CMT #	Page/ Para. #	Comments on DG-1081, SRP	NRC Staff Response
1.	Page 4, 1.1.2 DG-1081	<p>Add the following sentence at the end of the first paragraph of 1.1.2, Defense in Depth:</p> <p>"However, reliance on manual operator actions is acceptable if adequate time and information are available to the operator and if the facility modification results in significant hardware simplification (e.g., elimination of a complex automatic control system)."</p>	<p>The NRC staff believes that the proposed DG language is appropriate. While the simplifications described in the proposed language could be appropriate in limited circumstances, reliance on manual operator actions as a compensation for design deficiencies is generally unacceptable.</p>

Figure A-1: Measurements of Fission Gas Content in LWR Fuel Rods

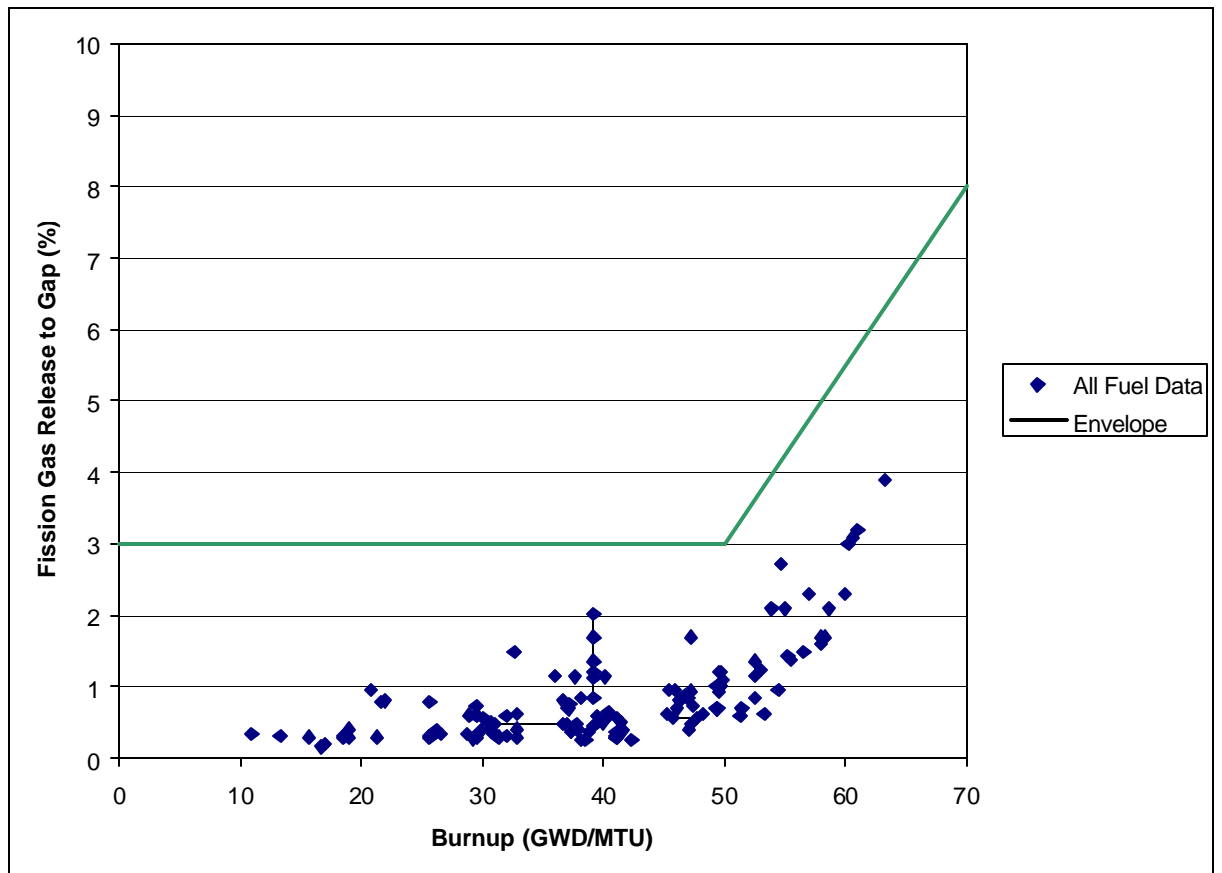
increases with burnup at a rate of about 2.3% per 10,000 MWd/MTU per reference [2]. In the table below, the middle column shows an envelope of the data. The right-hand column of the table shows the industry recommended gap fractions for use in analyzing non-LOCA events. The degree of conservatism of this proposed envelope relative to the data is illustrated in Figure A-1.
